Report to the Future Melbourne (Planning) Committee

Agenda item 6.3

**Ministerial referral: TPM-2016-4
51-65 Clarke Street, Southbank**

7 February 2017

Through block link

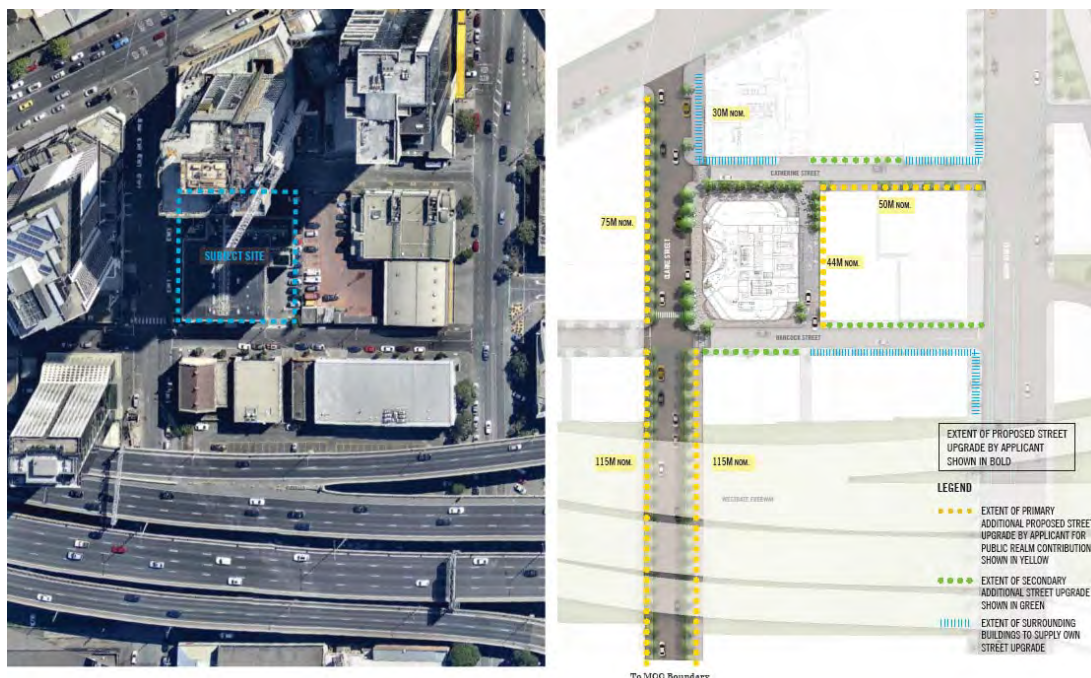
In relation to the through-block link, the quality of the space is not yet considered to provide a sufficient public benefit, particularly at the southern end of the link that provides access to the loading bay and car parking lifts. However it is considered that the through-block link has the potential to be a positive and supportable component of the public benefit.
